SUBJECT: **Request for Modification of the Section 404 Individual Permit and Section 401 Water Quality Certification** for the proposed East End Connector from NC 147 (Durham Freeway/Buck Dean Expressway) to north of NC 98 (Holloway Street) in Durham, Durham County, North Carolina, Division 5. Federal Aid Project No. NHF-76-1(2), TIP No. U-0071.

The purpose of this letter is to request a second modification to the United States Army Corps of Engineers (USACE) Section 404 Individual Permit and North Carolina Division of Water Resources (NCDWR) Section 401 Water Quality Certification for the above-referenced project.

In addition to this cover letter, please find enclosed new Wetland Permit Drawing Sheet No. 1A of 91 and revised Wetland Permit Drawing Sheet Nos. 36, 74, 90, and 91 of 91.

CULVERT SILL DETAILS

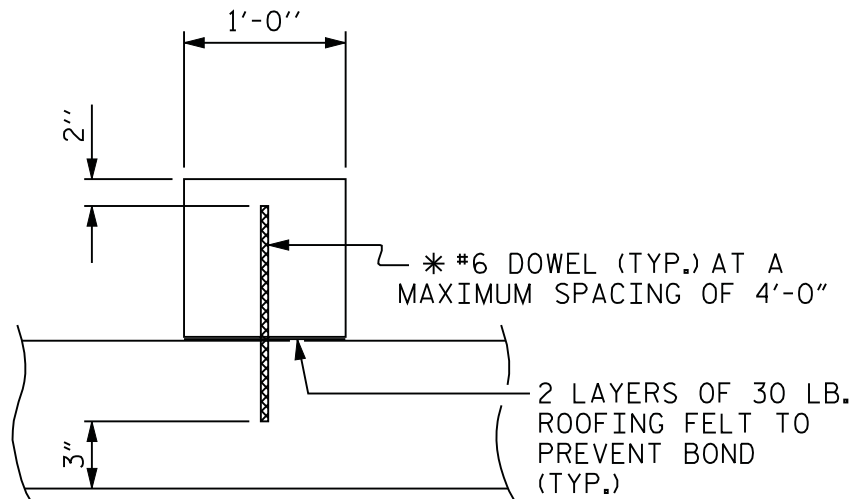
- **Culverts at 95+48 -L- Lt/Rt (Permit Site 7, Permit Drawing 36 of 91), 133+41 -L- Lt/Rt (Permit Site 17, Permit Drawing 60 of 91 [not included]), 34+45 -Y3- Lt/Rt (Permit Site 23, Permit Drawing 74 of 91), and 19+07 -Y4- Lt/Rt (Permit Site 7, Permit Drawing 36 of 91):** The contractor has completed installation of the single-barrel box culvert at 95+48 -L- Lt/Rt (Permit Site 7). The streambed has a headcut above the culvert inlet. The Department proposes to install a one foot sill at the inlet and outlet of the culvert at this location, as well as the other three culverts on the project (at Sites 7, 17, and 23). Please see added Wetland Permit Drawing Sheet No. 1A of 91 for the culvert sill detail.

Permit Drawing
Sheet 74 of 91
Revised October 2015

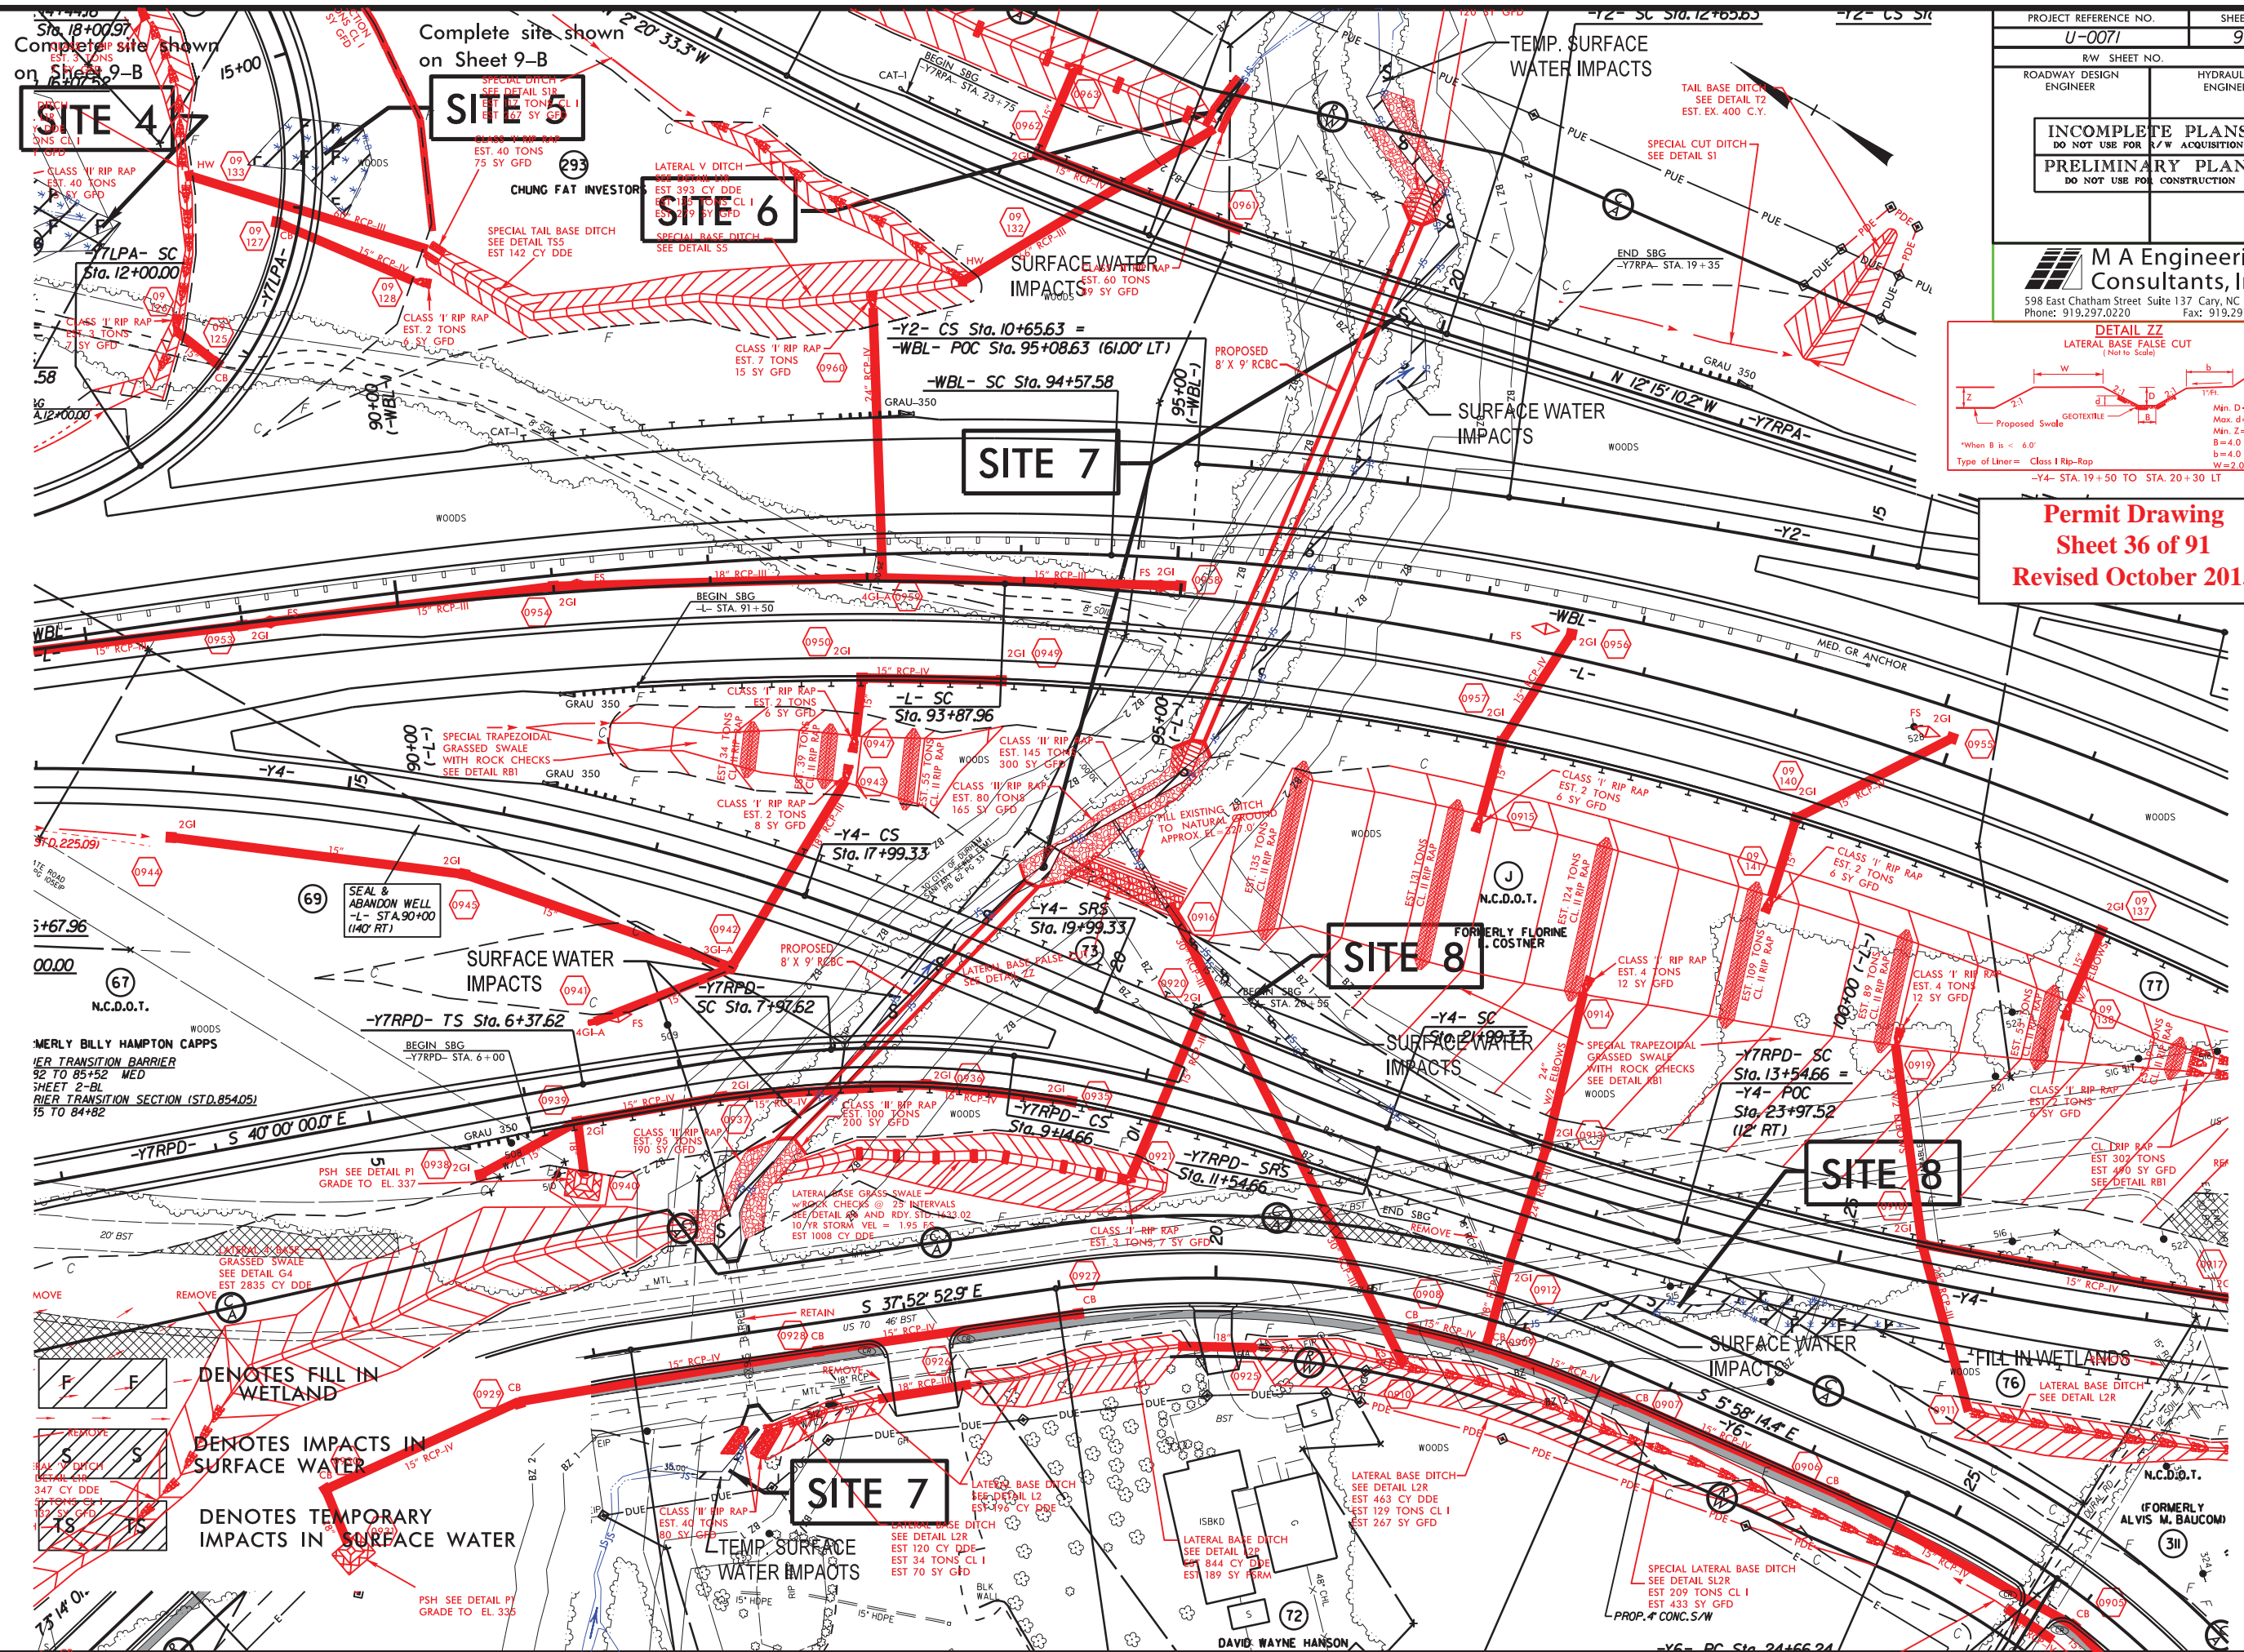
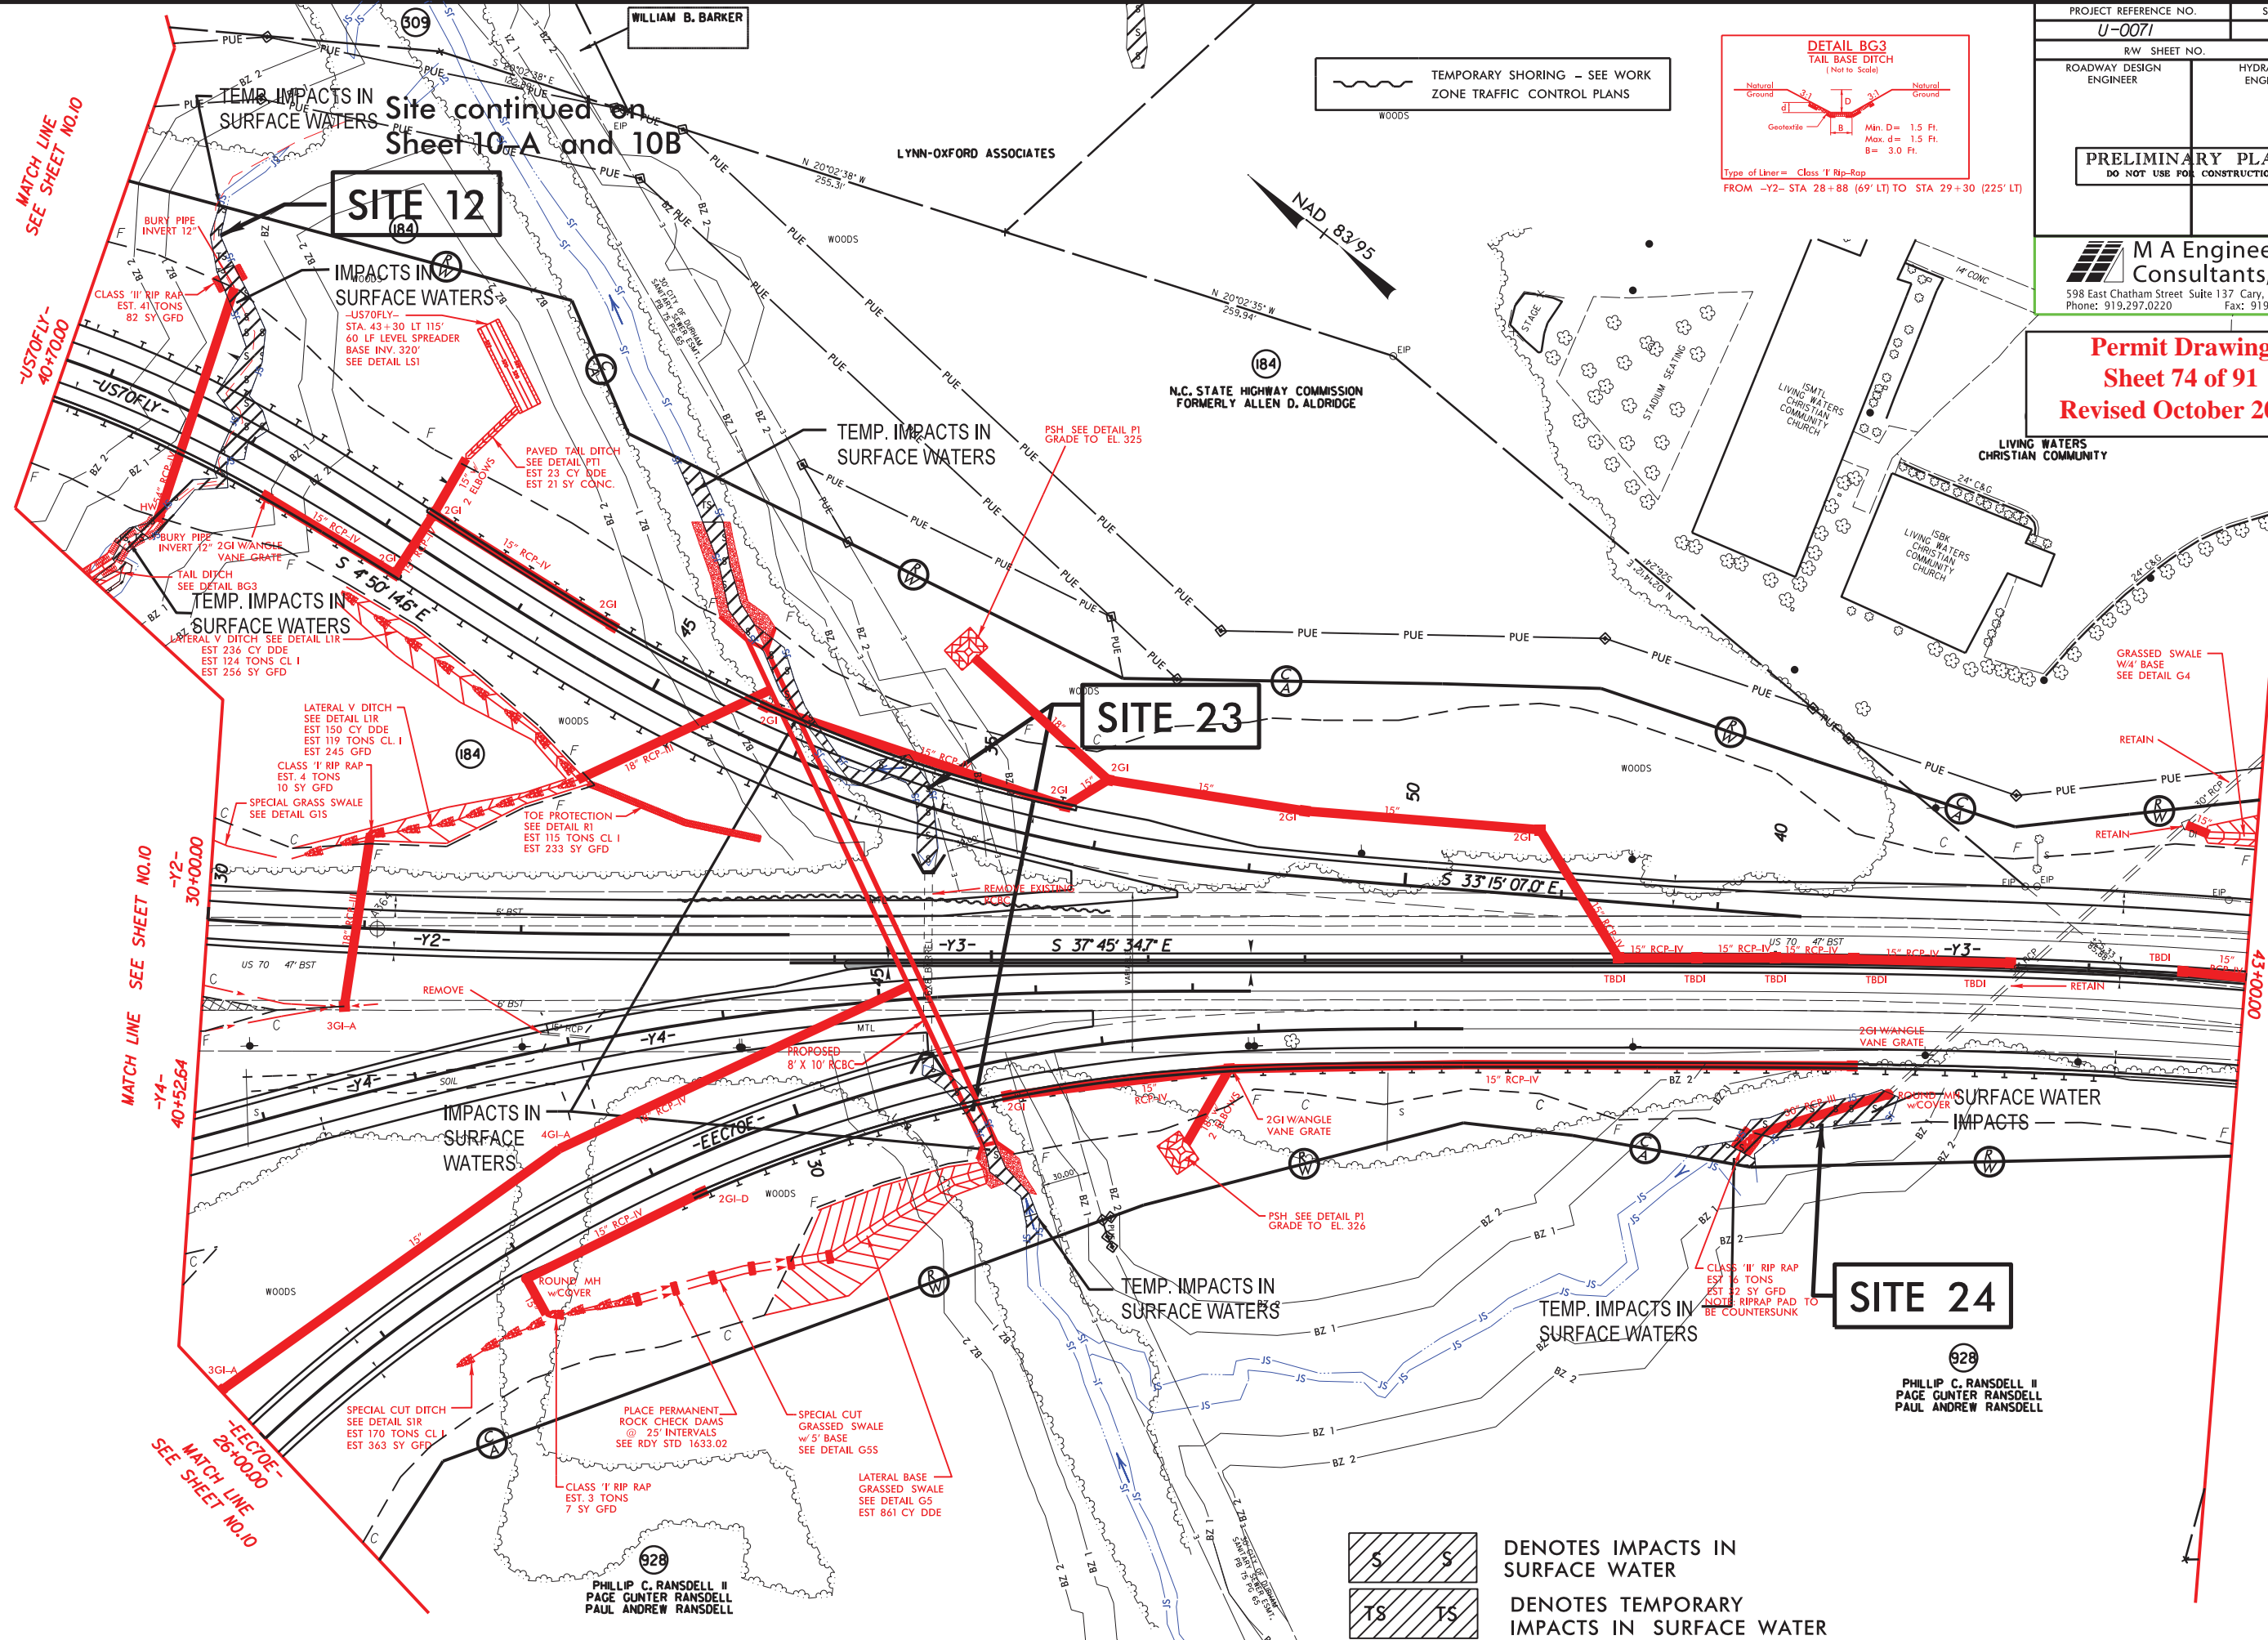
- **Permit Site 23 (Permit Drawing 74 of 91) at 45+00 -US70FLY- Lt:** The contractor is currently installing the single barrel culvert at this site. The Department has evaluated existing streambank stability downstream of the culvert and proposes to add additional Class II rip rap bank stabilization along both streambanks at the outlet to provide for enhanced permanent stability. This design change will result in a reduction in temporary stream impacts of 11 linear ft., a decrease in permanent stream impacts of 10 linear ft., and an increase in bank stabilization impacts of 13 linear ft.

- **Permit Site 12 (Permit Drawings 48 [not included] and 74 of 91) at 41+60 - US70FLY- Rt:** The original plan indicated construction of a tail ditch (with no flow line liner) to convey stream flow through the project. The Department has evaluated this design based on existing field conditions and now proposes to relocate the stream channel into a tail ditch with Class I rip rap in the flow line and on the banks. Please see Detail BG3 on Permit Drawing No. 74.
